THE SINGARENI COLLIERIES COMPANY LIMITED  
(A Government Company)  
Estates Department, Yellandu Area

Sub:- Proposal for diversion of 151.8517 Ha. of Forest Land in Yellandu Division for JKOC Project (Online proposal FP/TG/MIN/49581/2020) - MoEF&CC, Gol raised EDS-4 on 16.05.2024 - furnishing the reply to the EDS-4 -Reg.

Sub: TSFD - Forest (Conservation) Act 1980 - Diversion of 151.8517 Ha (earlier 106.304 Ha) of forest land for converting UG rights to surface rights for the proposed JK OC mine (JK 5OC Mine & 21 Incline Mine ) at Yellandu division in favour of M/s Singareni collieries company limited – **Additional information Sought by GoI. MoEF & CC, New Delhi** – Report submitted - Reg.

PLAN SHOWING THE AREAS OF REHABILITATED DUMPS  
AT JKOC-II PROPOSED FOR HANDING OVER TO STATE  
FOREST DEPARTMENT UNDER CA SCHEME  
YELLANDU AREA

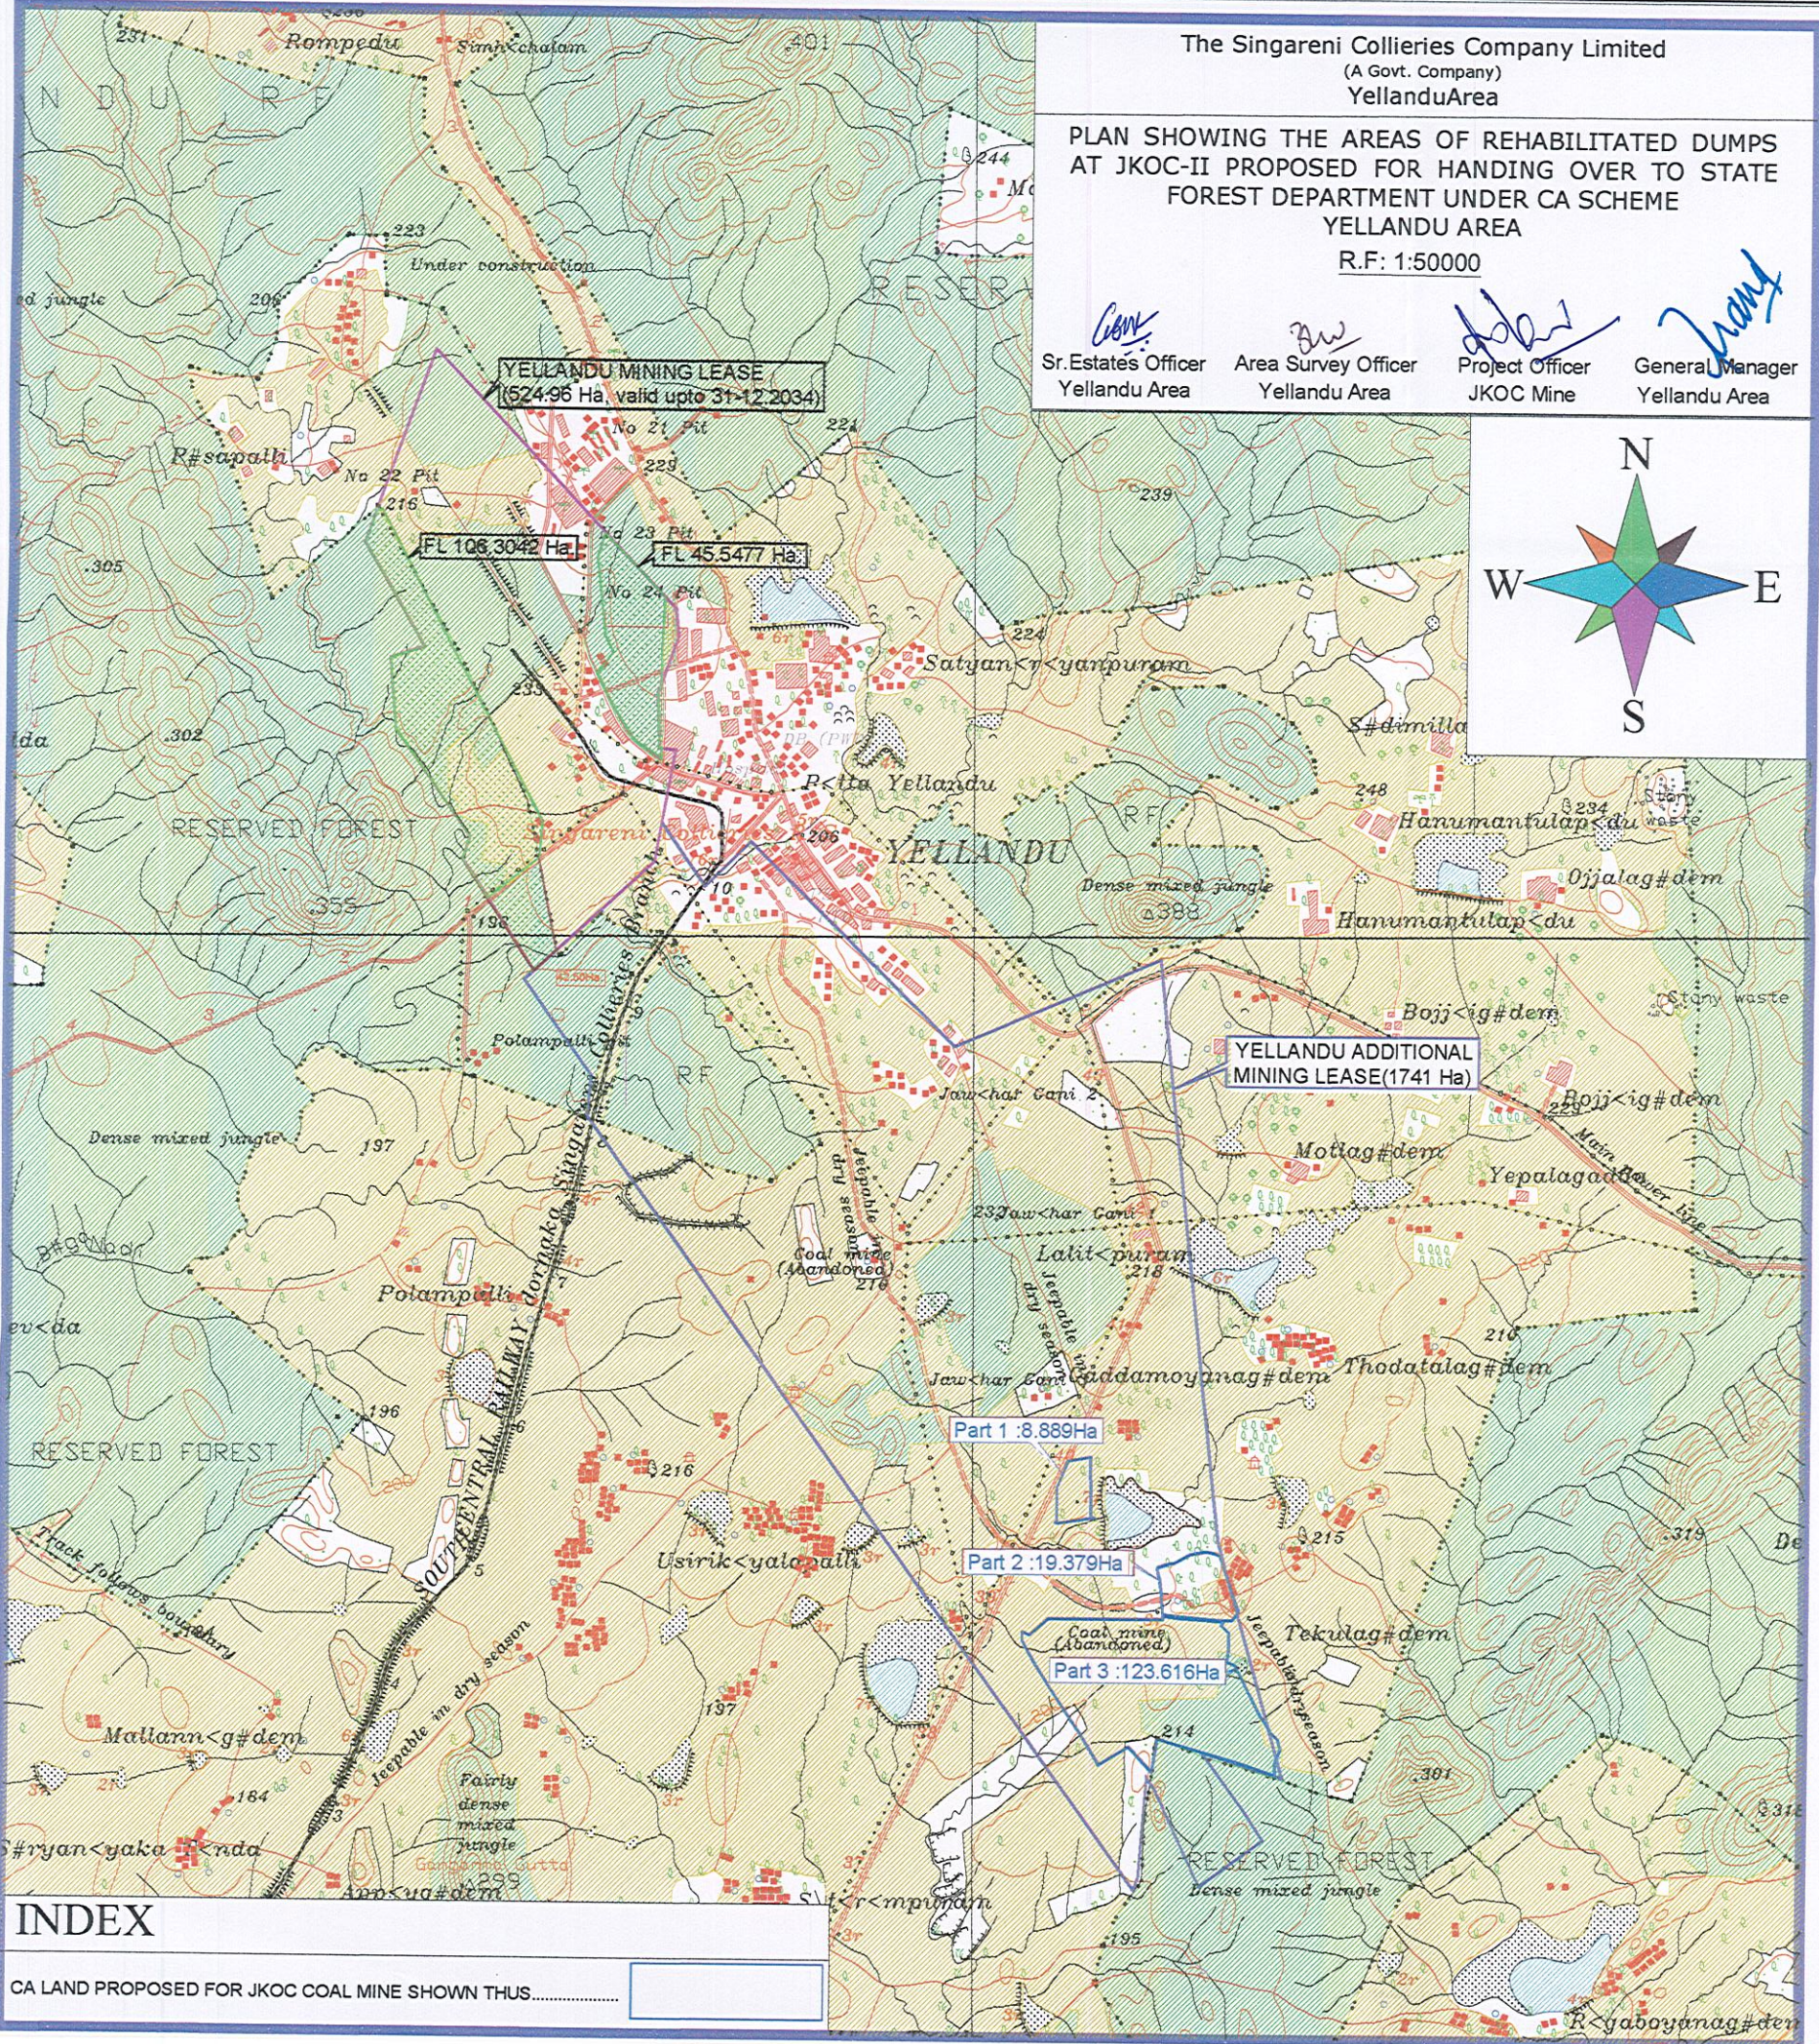
***Point No.v:- As per the site inspection report by the Regional Office the exact area proposed for the CA (NFL-rehabilitated OB dump area), is not demarcated completely (verified and measured) and there may be a possibility of encroachment in the fringe areas. In this regard the State Govt. shall demarcate the area and submit exact details along with plan to protect the said area for its protection and management.***

The Proposed CA land of 151.8517 Ha was resurveyed and demarcated completely (verified & measured). Out of 151.8517 Ha of given CA land an extent of 8.889 Ha was identified with encroachments at fringes.

SCCL identified the alternate CA land in the adjacent area. The KML file of 8.889 Ha of alternate CA land is enclosed.

The General Manager, SCCL Yellandu vide his reference No. Yellandu GMO 2024 G 583, dt: 05.06.2024 was requested to the District Forest Officer, Khammam for arrange for inspection of alternate CA land of 8.889 Ha and to submit the report to the Principal Chief Conservator of Forests. Copy of Plan showing the alternate CA land of 8.889 Ha is enclosed as Annexure-VI.
